Amendments to the Drawings

Docket No.: C0852-7014
Date: December 8, 2005

Applicant: Robert B. Chaffee
Serial No: 09/859,706
Confirmation No: 4125
Filed: May 17, 2001
For: INFLATABLE DEVICE WITH RECESSED FLUID
CONTROLLER AND MODIFIED ADJUSTMENT DEVICE

Fig. 4

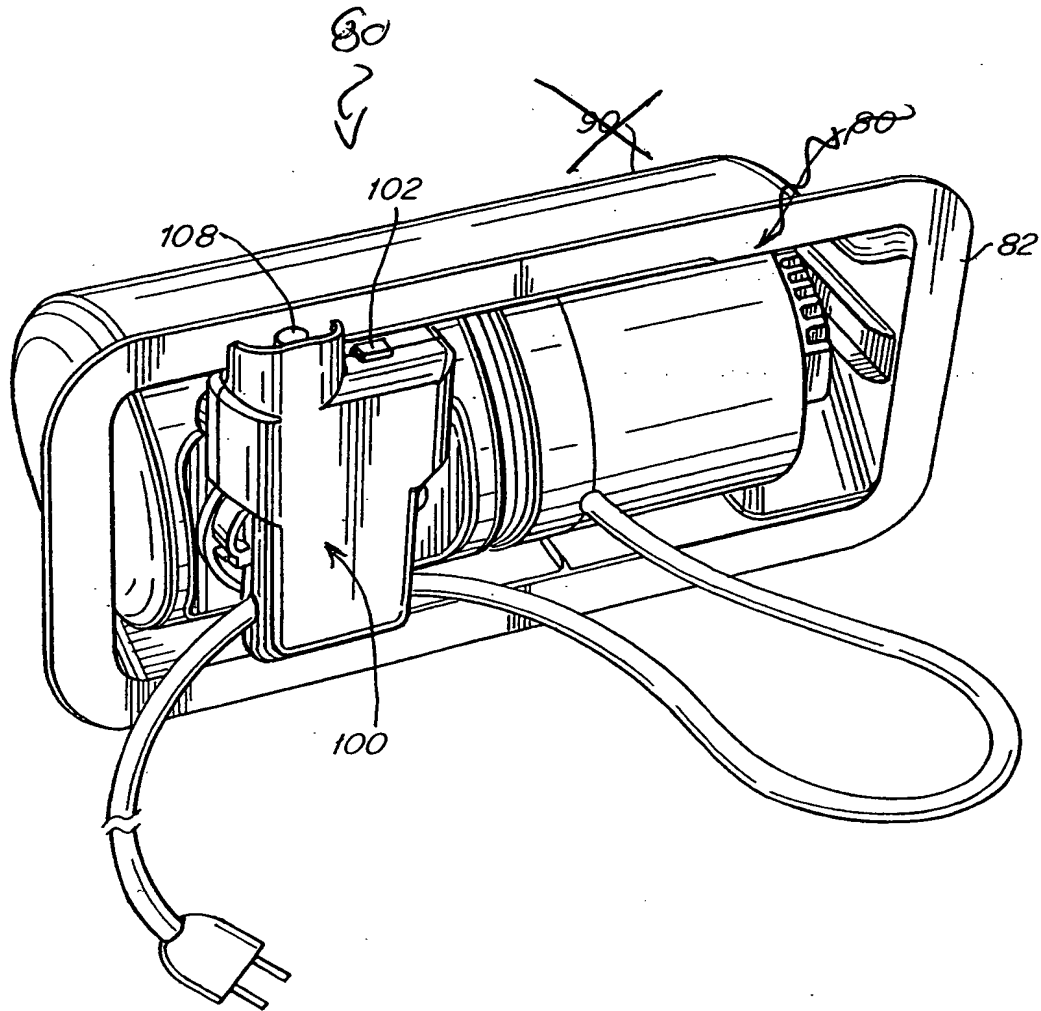
The Office Action objects to the drawings as failing to comply with 37 CFR 1.84 (p)(4) because reference character “90” has been used to indicate both the housing “90” connected to the flange “82” as shown in FIG. 3 and the housing or covering around the motor (84), impeller (86), conduit (88), solenoid (104), etc. as shown in FIG. 5. Applicant has deleted reference character 90 from FIGS. 3 and 4 of the enclosed annotated drawings so as to eliminate any confusion. It is clear from the specification that the reference character 90 refers to the housing 90 that surrounds the inner workings of the pump 81, such as the motor (84), impeller (86), conduit (88), solenoid (104), etc., and can also serve as a connection between the fluid controller 80 and the bladder 20. Accordingly, withdrawal of this objection is respectfully requested.

The Office Action also objected to the drawings asserting that the reference numerals “83” and “90” have both been used to designate “fluid impermeable wall” (see FIG. 5) and “housing” (see FIG. 3). As noted above, FIGS. 3 and 4 have been amended to eliminate to reference character “90” from these figures, as the fluid impermeable wall is designated by the reference number 83 in FIG. 5. Accordingly, the drawings have been corrected and withdrawal of this objection is respectfully requested.

As to claims 5, 6, 8, 9, and 26, the Office Action asserts that they all recite a "housing" which is confusing because the specification and drawings are not clear as to what constitutes the housing (i.e., is it the structure connected to the flange (82) as shown in FIG. 3 or is it the structure surrounding the motor (84), impeller (86), conduit (88), solenoid (104), etc. as shown in FIG. 5?). As has been discussed above, the housing 90 surrounds, for example, the motor, the impeller, the conduit, the solenoid, etc. as shown in FIG. 5 and any reference to the housing 90 in FIGS. 3 and 4 have been deleted. Thus, the drawings have been corrected and the claims are
